Re: Request for TEDS Exemption - 2301 Logos Drive

Re: Design Exception #DE04-06- Driveway Spacing for 2301 Logos Drive

DESIGN EXCEPTION #4-06

RE: Driveway spacing for 2301 Logos Drive

cc: Proposed Site Plan

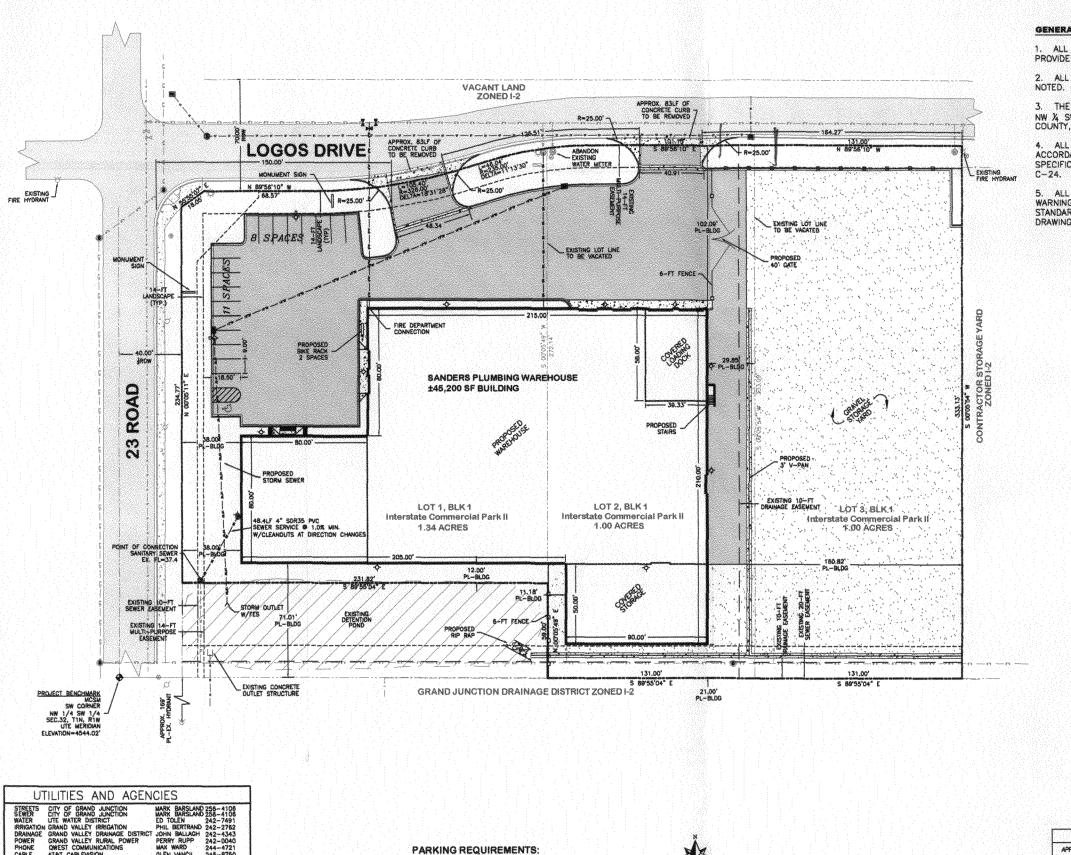
The applicant is requesting an exemption from the 150-ft spacing between driveways. The design the applicant has proposed provides 126.51-ft between the two site access locations.

Alternative two would be to adjust the location of the eastern most site access point to provide 150-ft of separation. This adjustment would require the access to shift approximately 23.5-ft to the east, which will impact an existing single inlet storm sewer drain. In addition to impacting the existing storm inlet, this option makes access to the semi-truck loading dock area more difficult.

Alternative three would be to grant the exemption and allow the driveways to be separated by 126.51-ft. Granting this request does not present any additional safety concerns. The proposed site plan provides 150-ft spacing separation from 23 Road and the primary site access point for most of the vehicles that enter and exit the facility. From a safety standpoint, the separation between 23 Road and the first site access point is the most critical because this spacing is necessary to provide space for vehicles to stack at the 23 Road intersection. The eastern most access point will be used primarily by large semi-trucks which is a better location because the trucks will need to swing into the oncoming traffic lane in order to make the turn into the site because the access width cannot be wider than 40-ft. Shifting the access an additional 23-ft to the east will not provide any additional degree of safety and does not cause any problems with adjacent site access points because there are no adjacent site accesses. This project reduces the number of potential accesses on Logos drive by combining three lots and reduces access to two locations.

We believe alternative three, granting a 23.5-ft exemption to Section 4.1.1 of the TEDS, is the best compromise for both the City and the applicant. The 23.5-ft exemption does not create any additional safety issues from an access standpoint and minimizes the impacts to the existing stormwater infrastructure. If you have any additional questions or concerns, please give me a call at 242-7540.

Staff recommends denial of the request. The TEDS standard for spacing can be met by shifting the eastern driveway approximately 23.5 feet to the east. Additionally Staff recommends the east driveway be constructed on the eastern property line and the applicant execute a cross access easement with the undeveloped lot to the east (Lot 3) and plan to share this access point with Lot 3.
